# Wizards Workshop

Published by Service Admin Support  
56-037

April 24, 1981  
Issue 11-7

### 7854, PREVENTION OF POSSIBLE CRT BURNS

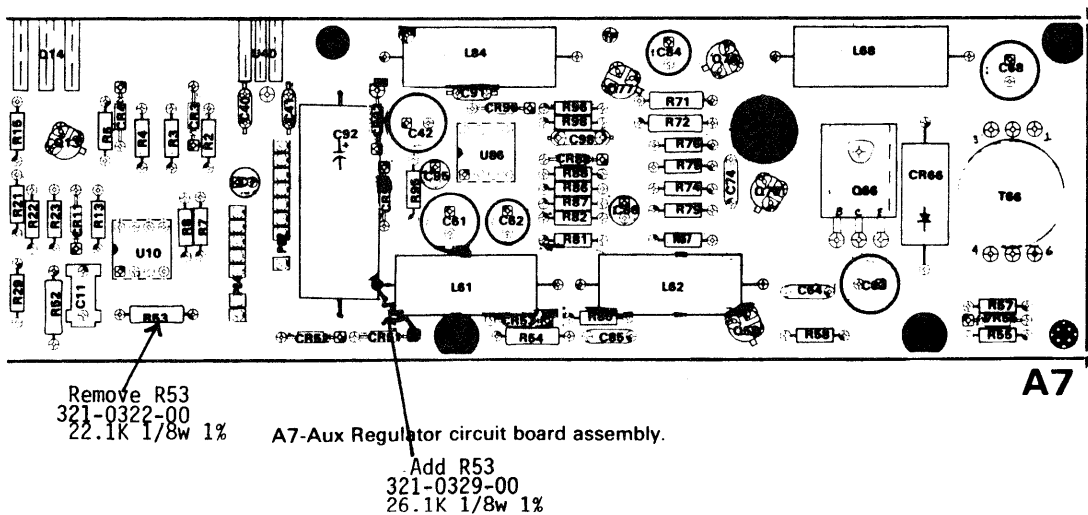
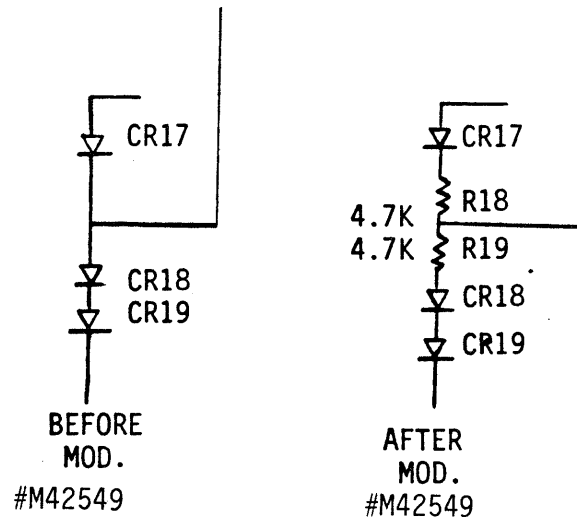
To assure performance and reliability Mod's #42549 and #M42913 should be installed as follows:

Mod #M42549 was first installed at Serial Number B010420 and consisted of removing CR17 and replacing it with P/N 152-0242-00, which is teeped with R18, 4.7K ohm, P/N 315-0472-00, which is a new part. Add R19, 4.7K ohm, P/N 315-0472-00, which is teeped in series with existing CR18. Mod #M42913 is being installed with serial numbers of B010600 and greater. This mod removes A7R53, 22.1K ohm, P/N 321-0322-00, resistor. The value is increased to 26.1K ohm, P/N 321-0329-00, and connected to the -17 volt supply. On the schematic this will show as R53 in the same position, but connected to -17 volts instead of -15 volts. See the following remove/add sketches and schematics for further info.

*NOTE: Both mods should be installed in instruments B010420 and below, and Mod #M42913 installed in instruments with serial numbers from B010421 to B010599.*

# SPG1 MANUAL ERROR CORRECTION

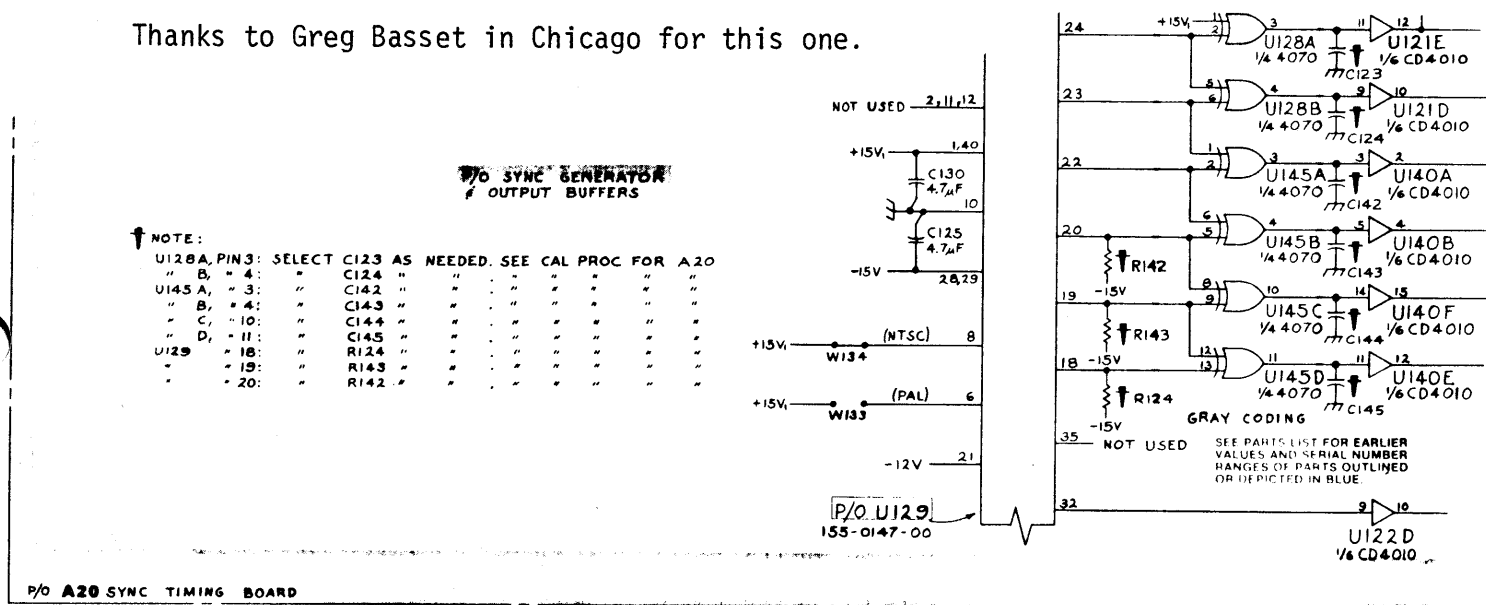
During a recent update of portions of the SPG1/SPG2 Instruction Manual, some circuit details were inadvertently left out. The diagram below shows the circuit in question (Sync Timing  a). This circuit applies up to S/N B019999. After B020000 the manual schematic is basically correct in this area. Manual correction requests have been submitted.

### TDC VOLTAGE CONTROLLED OSCILLATOR, A8U (UHF)

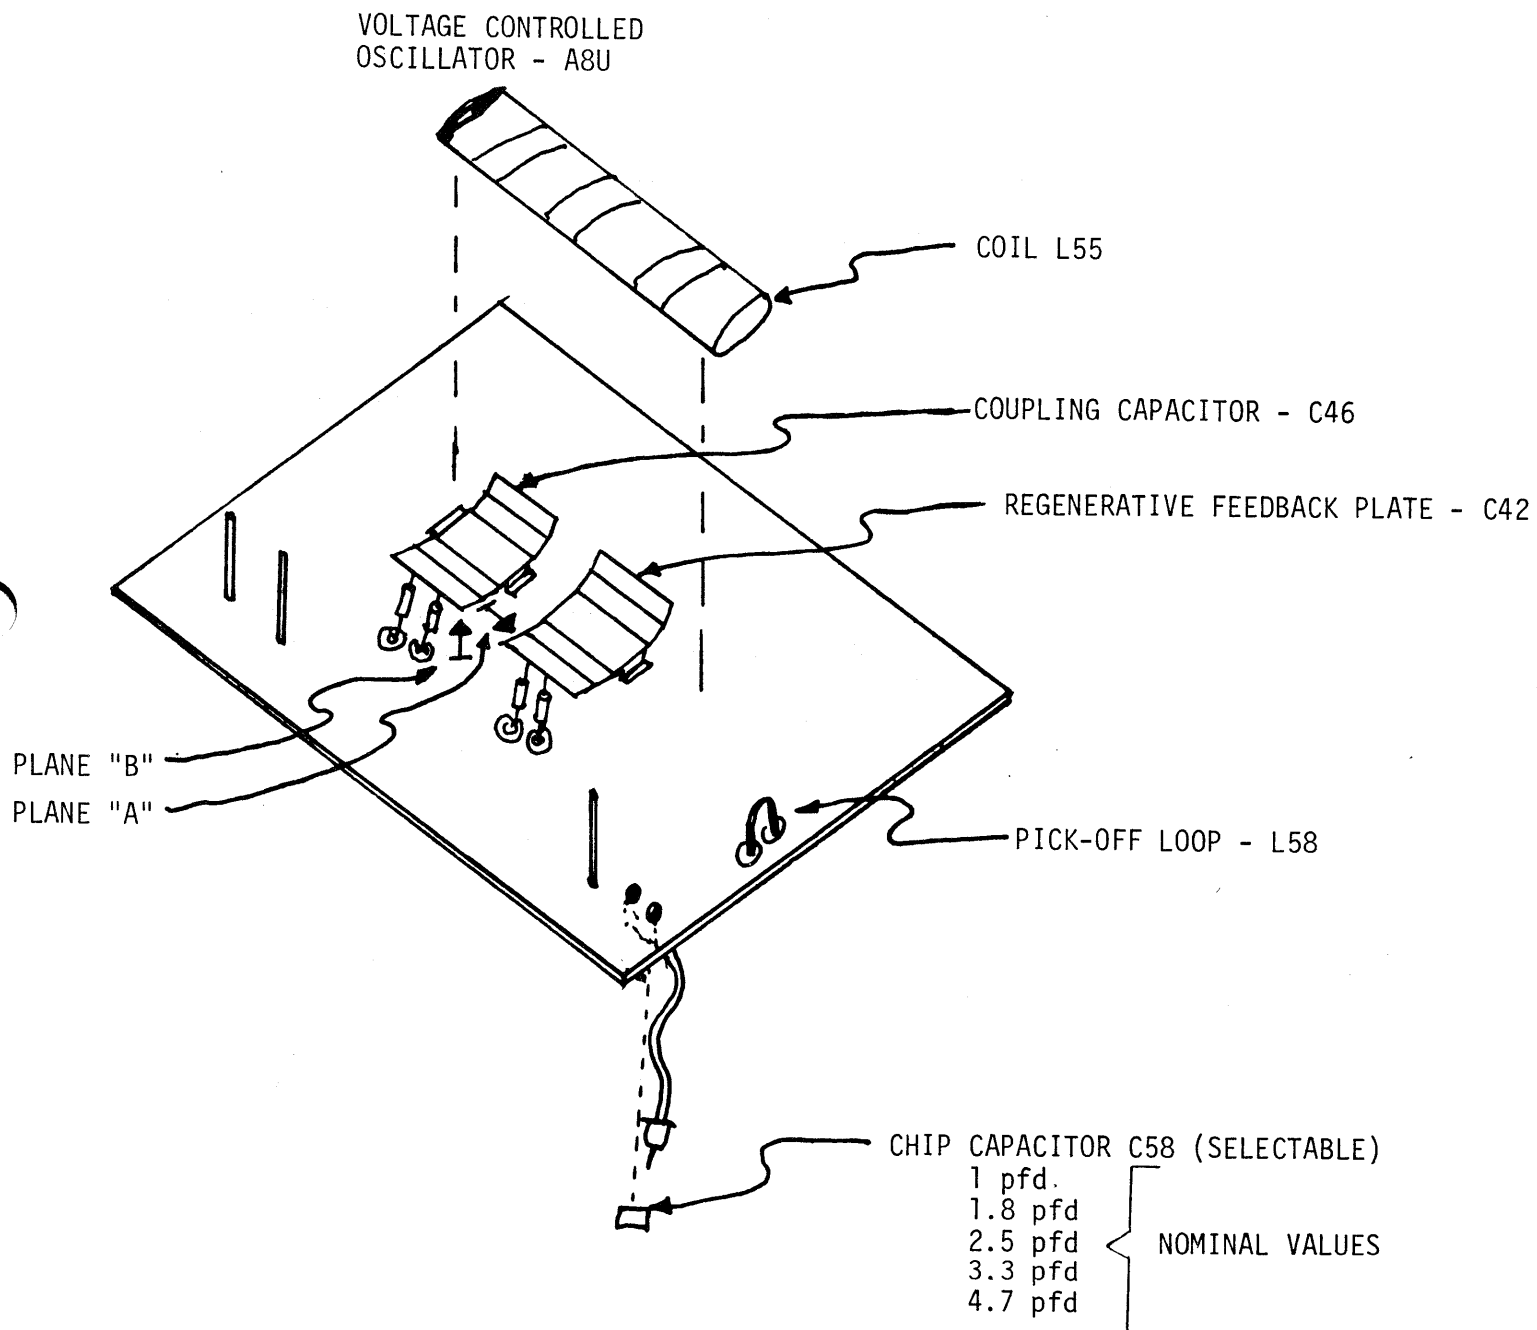
The coupling of power between the ceramic coil (L55) and the coupling plate (L46) is directly related to the metallic surface areas of the two parts. This becomes critical at higher frequencies where the 2 and 3.8 turn coils' metal strip is cut to short lengths to provide resonance at these wavelengths. The problem arises when only a small surface area of metal is available to place in close proximity with coupling plate C46. At this point, it is advisable to use the "barberpole" effect to position as much area as possible above C46.

Another useful method is to actually move C46 along plane "A" (see diagram) towards C42, being careful not to break the metal support tab or the standoff resistors in the process. If it is possible to also move C46 in plane "B" towards the coil, this is also helpful.

If, at any time, the oscillations disappear entirely, the coupling plate (C42) may also have to be moved or bent to facilitate regenerative feedback for Q33.
